3 February 2026

IEAPM Ref: 2026-02-L2

IEAPM Advice on Hunter Valley Operations Continuation Project (SSD-11826681 and SSD-11826621)

Figure 1: Highlighted figure taken from Appendix E Greenhouse gas assessment (Aug. 2025; figure 3.12) with Scope 1 CO₂-e emissions.

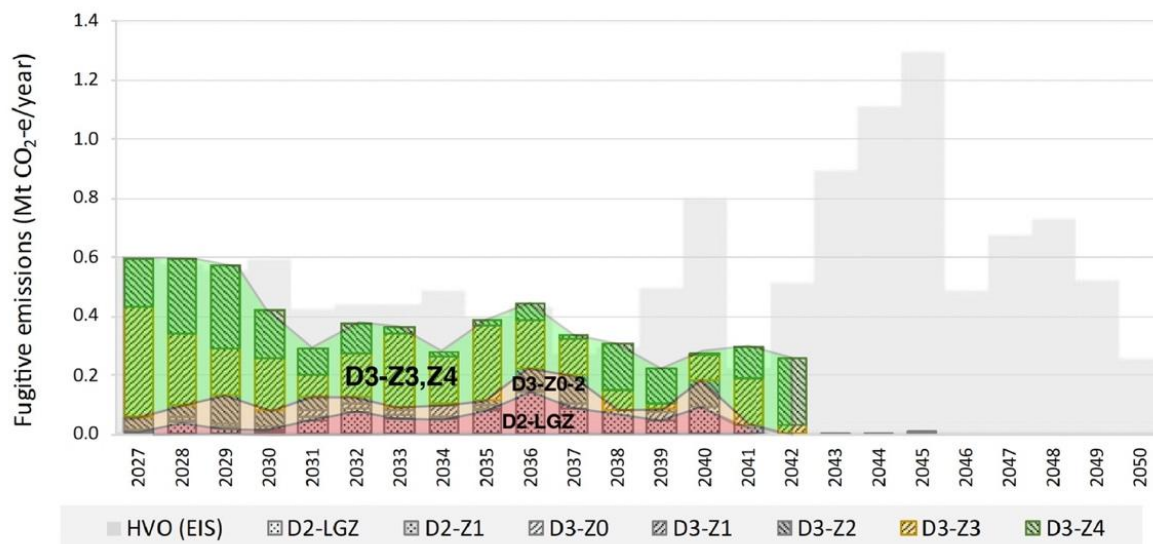
The Panel notes that mining in the higher gas zones of Domain 3 will occur in the period 2027 to 2029 (see Fig. 1 above), so *high priority needs to be given to the PFS*. In this regard, the Applicant should include in the PFS the proposed pathway and a schedule to potentially drain these higher gas zones.
